# OCHOCOTRAILS

Comment on Lemon Gulch Trail System #58831

Ochoco Trails is pleased to provide our comments on the Lemon Gulch Trails Proposal.

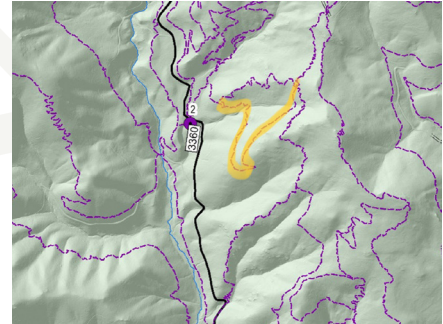
2. Reinstate the short trail near the middle area of the network (image included). This trail, which is isolated on an open ridge line and surrounded by other trails, was included in Alternatives #2, #3, and #4. The EA does not appear to identify any environmental or resource concerns, grazing concerns, or fragmentation of wildlife habitat related to this trail. While short in distance, this trail would provide an additional easy trail. OT would like to see this trail included in Alternative #6.
